**WHISKEY ISLAND BACK BARRIER MARSH
CREATION PROJECT
STATE PROJECT NO. TE-50**

PROJECT COMPLETION REPORT

**Prepared for:
Coastal Protection and Restoration
Authority of Louisiana**

PROJECT NAME: Whiskey Island Back Barrier Marsh Creation Project
CWPPRA/STATE PROJECT NO. TE-50

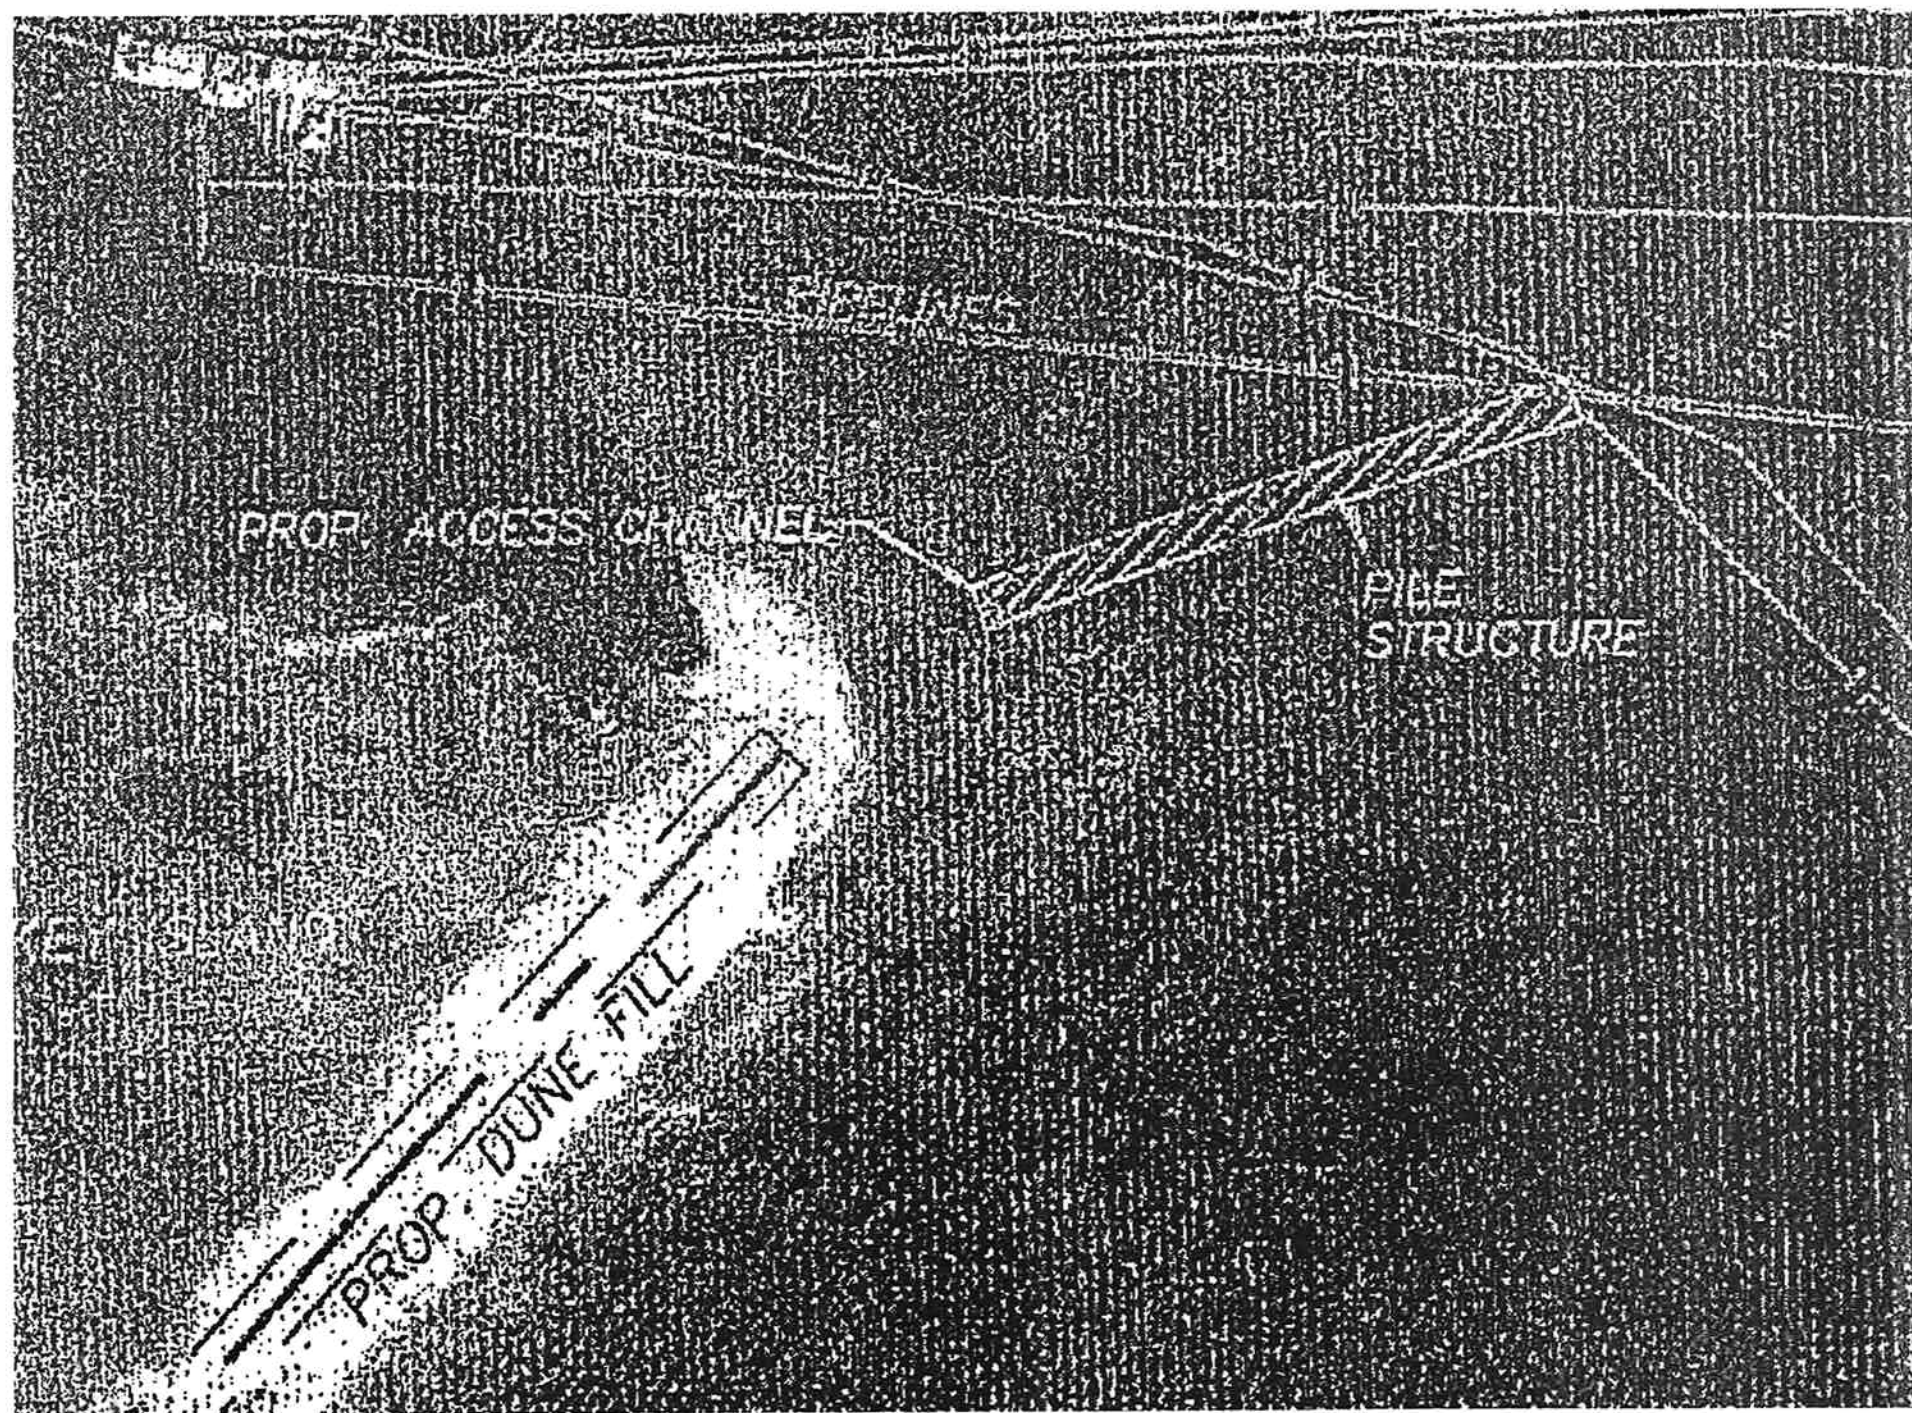
As discussed onsite on April 22, 2009, the Department of Natural Resources/Office of Coastal Protection and Restoration would like to remove the pile structure located on the east side of the above referenced project. At this time, DNR/OCPR is requesting a cost proposal to remove the pile structure located in Whiskey Pass. Please submit pricing to this office to remove and properly dispose of the pile structure located in Whiskey Pass on the east side of the project site and as shown on the attached drawing.

090105 BASE-Compore Dune.dwg

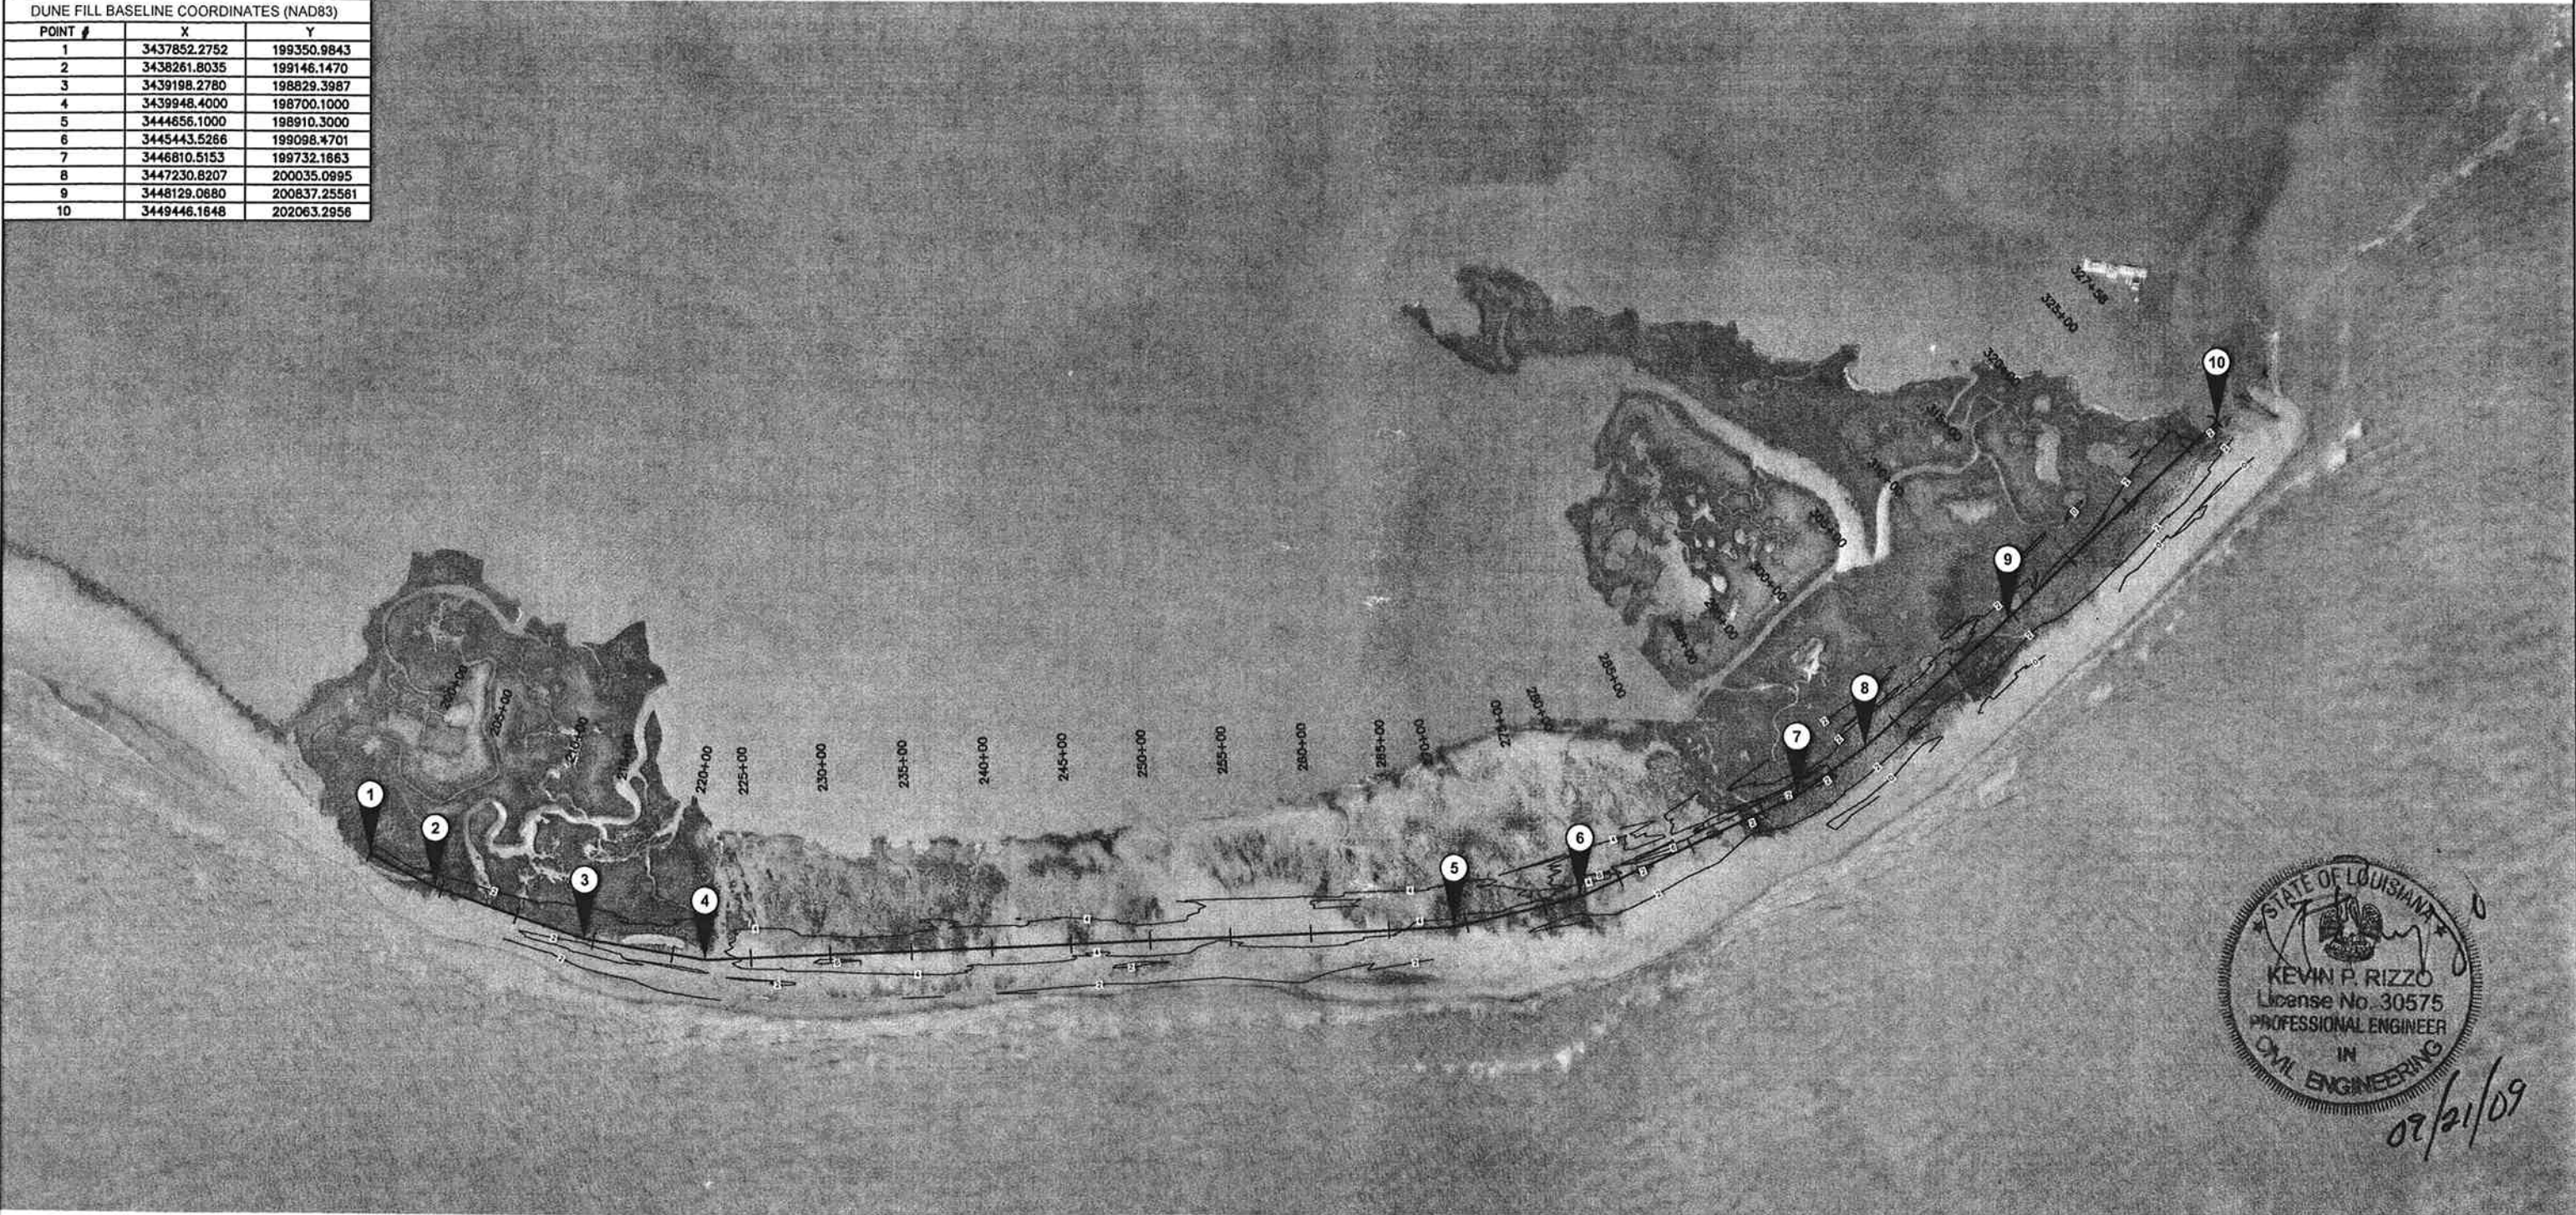
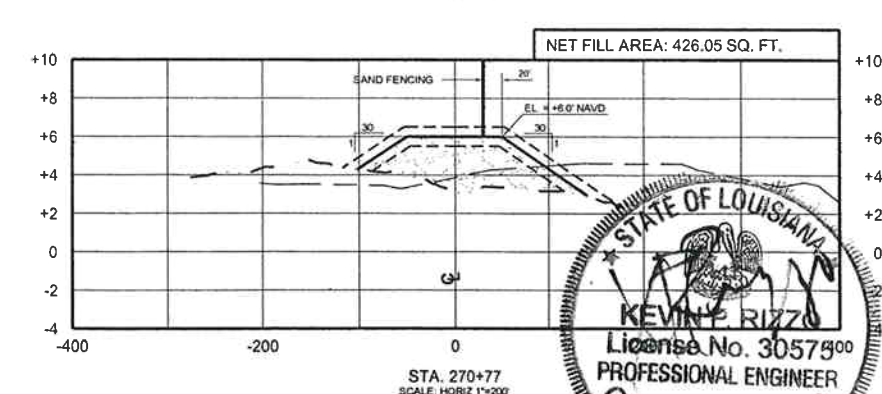
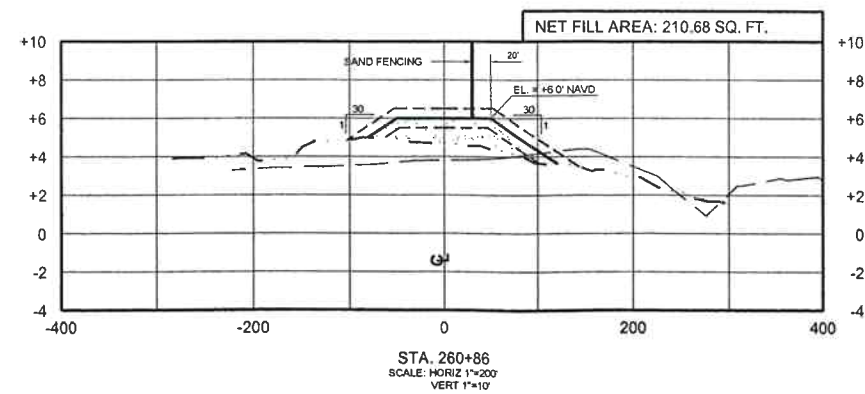
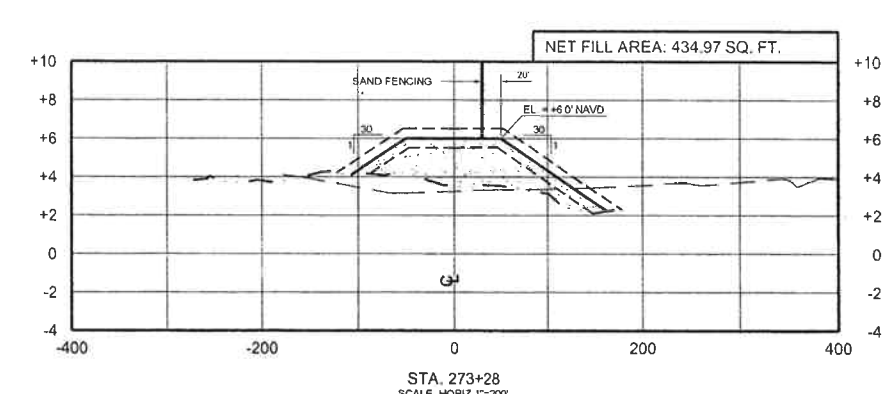
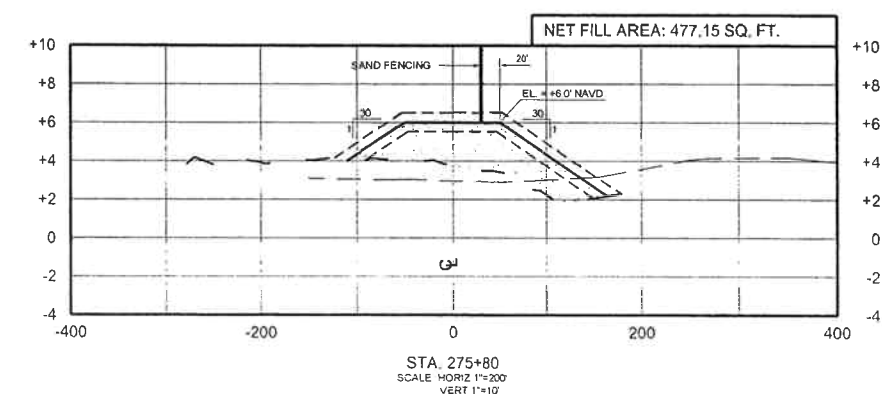
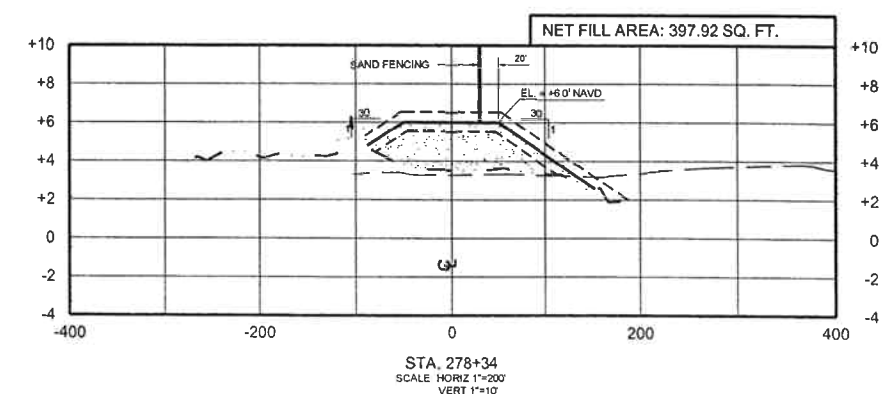
Change Order No. Two (2) is necessary revise the pay quantity of Item No. 11 to incorporate additional dredge material required due to realignment of dune feature. Realignment was required to due to changes to the physical features of Whiskey Island from design surveys and construction surveys.

Change Order No. Two (2) is necessary revise the pay quantity of Item No. 11 to incorporate additional dredge material required due to realignment of dune feature. Realignment was required to due to changes to the physical features of Whiskey Island from design surveys and construction surveys.

DUNE FILL BASELINE COORDINATES (NAD83)		
POINT #	X	Y
1	3437852.2752	199350.9843
2	3438261.8035	199146.1470
3	3439198.2780	198829.3987
4	3439948.4000	198700.1000
5	3444656.1000	198910.3000
6	3445443.5266	199098.4701
7	3446810.5153	199732.1863
8	3447230.8207	200035.0995
9	3448129.0680	200837.25561
10	3449446.1648	202063.2956

SHEET 9 OF 13

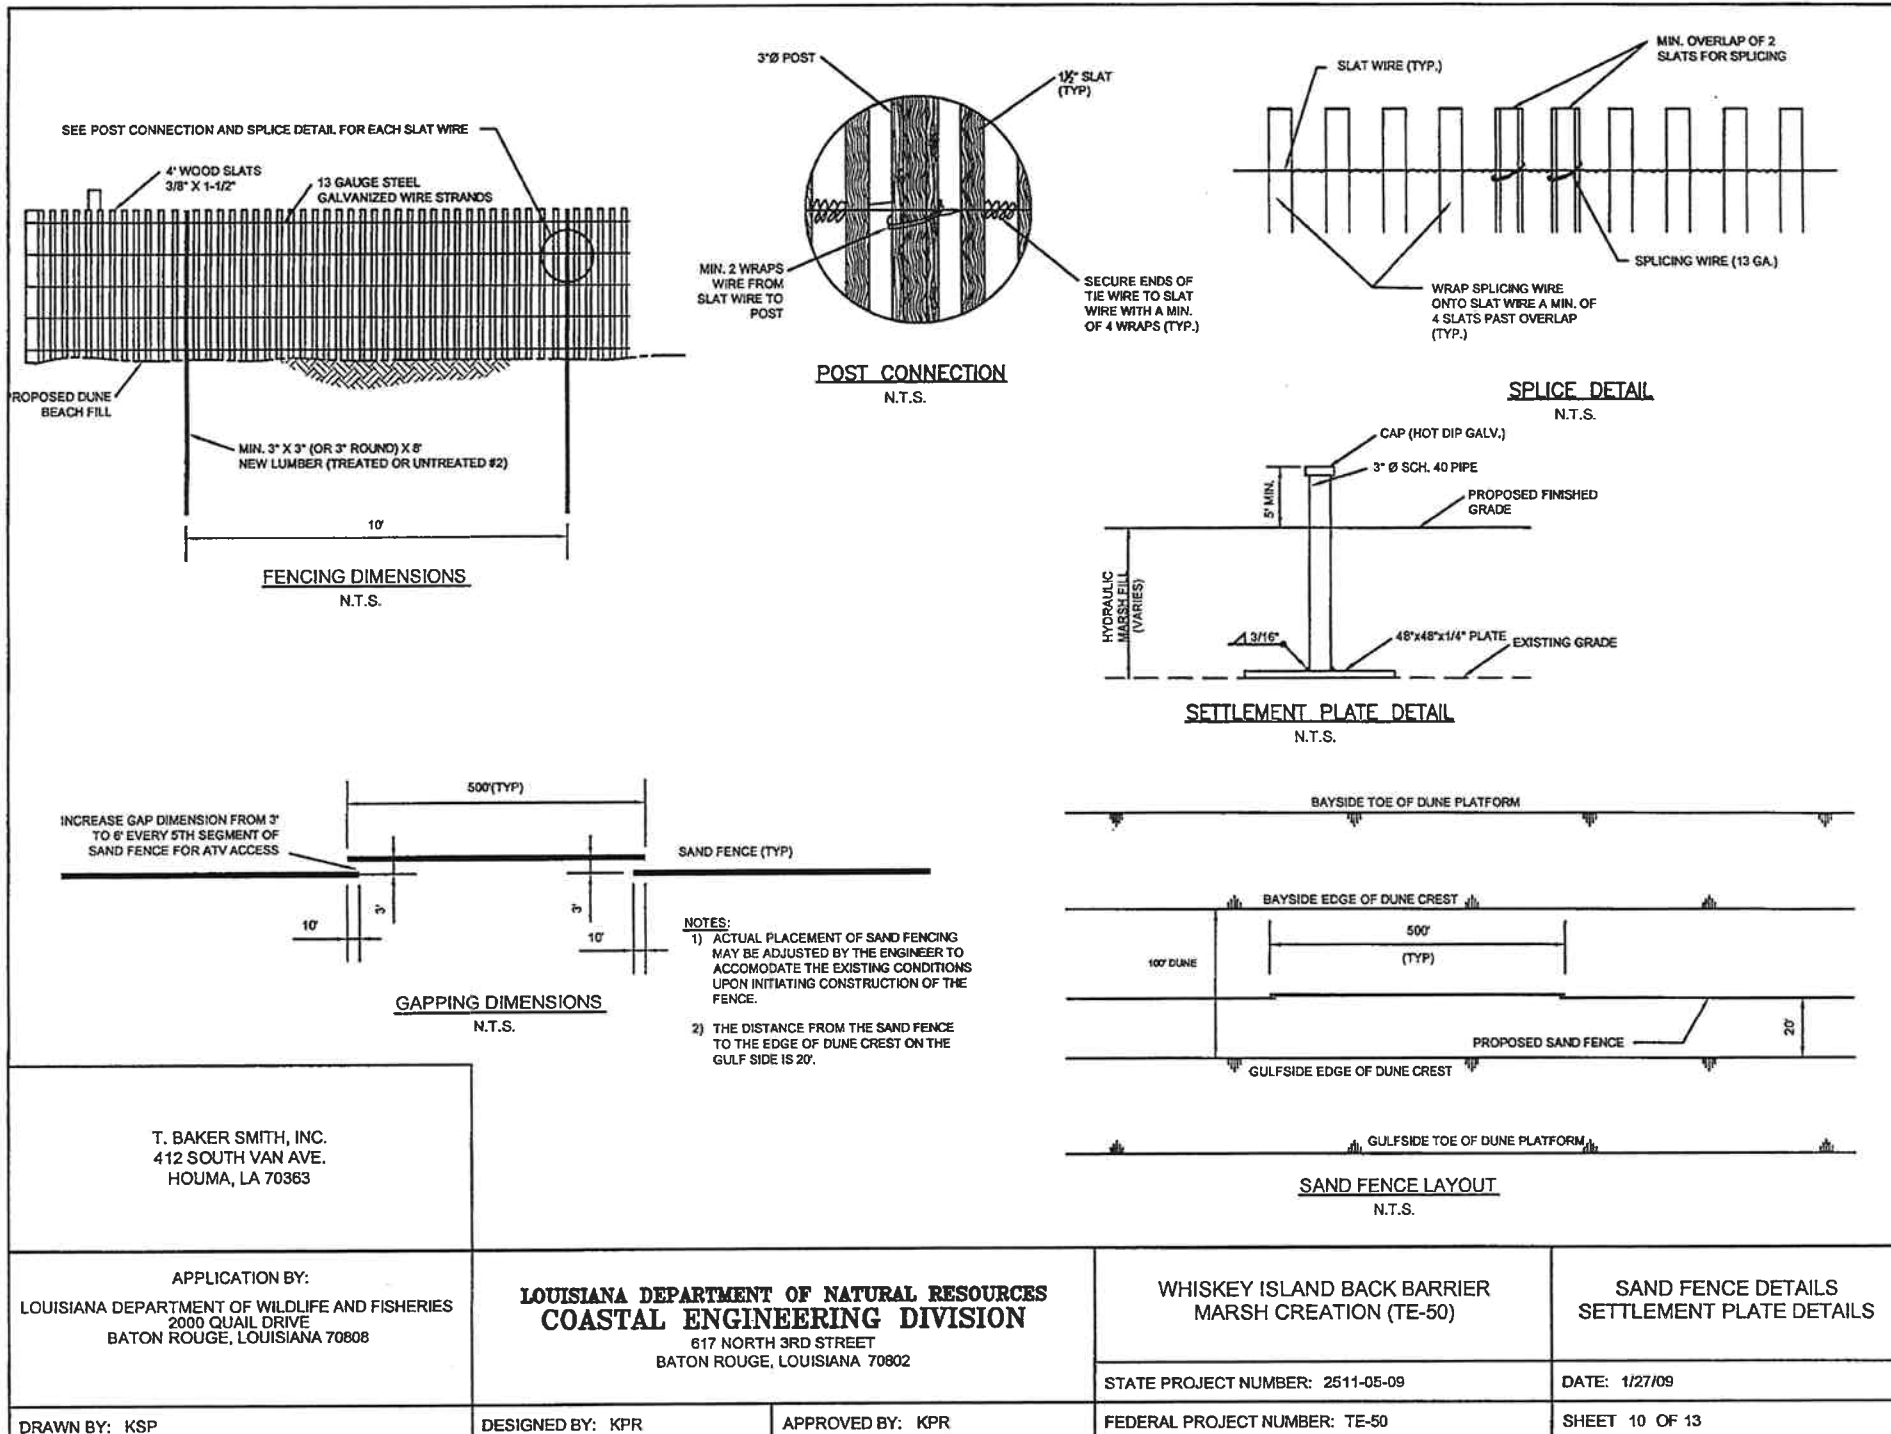
The Owner has received a permit modification include an access channel from Caillou Bay to the primary containment dike. The approved access channel is oriented perpendicular to the primary containment dike, with the intersection of the center of the access channel and primary containment dike being located at Point No. 28 as shown on Plan Sheet 5 of 22 of the contract documents and on sheets 3 of 13 and 9 of 13 of the Department of the Army project permit.

The Owner has received a permit modification include an access channel from Caillou Bay to the primary containment dike. The approved access channel is oriented perpendicular to the primary containment dike, with the intersection of the center of the access channel and primary containment dike being located at Point No. 28 as shown on Plan Sheet 5 of 22 of the contract documents and on sheets 3 of 13 and 9 of 13 of the attached permit.

Additional plans enclosed in sheets 2, 3, 6, 9 and 13 furnished with your application dated February 9, 2009, requesting an additional 300 feet of access channel and a 1.0-foot increase in channel depth from -5.0 to -6.0 feet NAVD 88 are approved and will be included in your plans for the work authorized by the Secretary of the Army in permit dated June 5, 2008, granting approval to dredge to construct a temporary access channel and excavate and deposit material to reconstruct the dune complex, install containment dikes and a sand fence, and build a marsh platform with tidal creeks and ponds, all for the purpose of implementing the Whiskey Island Back Barrier Marsh Creation Project (CWPPRA TE-50) located in the Isles Dernieres Island chain, Whiskey Island, approximately 17 miles southwesterly from Cocodrie, Louisiana, in Terrebonne Parish. These drawings along with the remaining set of drawings have been re-dated to January 27, 2009, and, therefore, will supersede all drawings of your original permit.
